Deer Creek Review

REVIEW OF MINE PLUG INSTALLATION PLAN

Deer Creek Mine

Plate 1: 2014 National Seismic Hazard Map for Utah

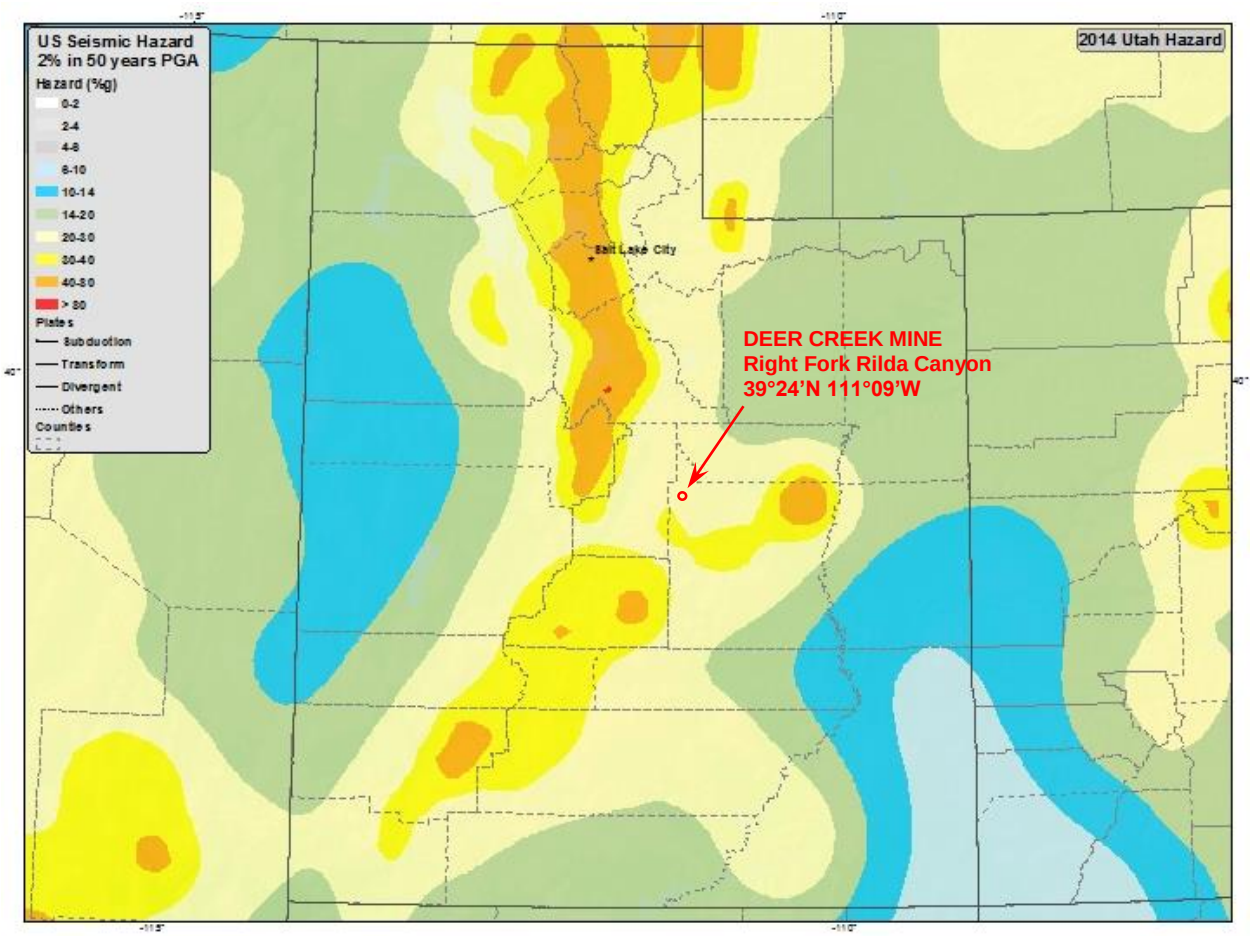
In calculating factors of safety against the potential increased load provided by seismic activity, Plate 1 downloaded from the 2008 U.S. Geological Survey (USGS) National Seismic Hazard Maps collection for Utah (USGS, 2014), shows that the estimated peak ground acceleration (PGA) with a return period of 4,975 years (i.e., at a probability of 2% over 50 years) is approximately 0.27 g – yielding a short-duration, additional water hammer load (per Lang, 1999) on the plugs of approximately 30 psi.
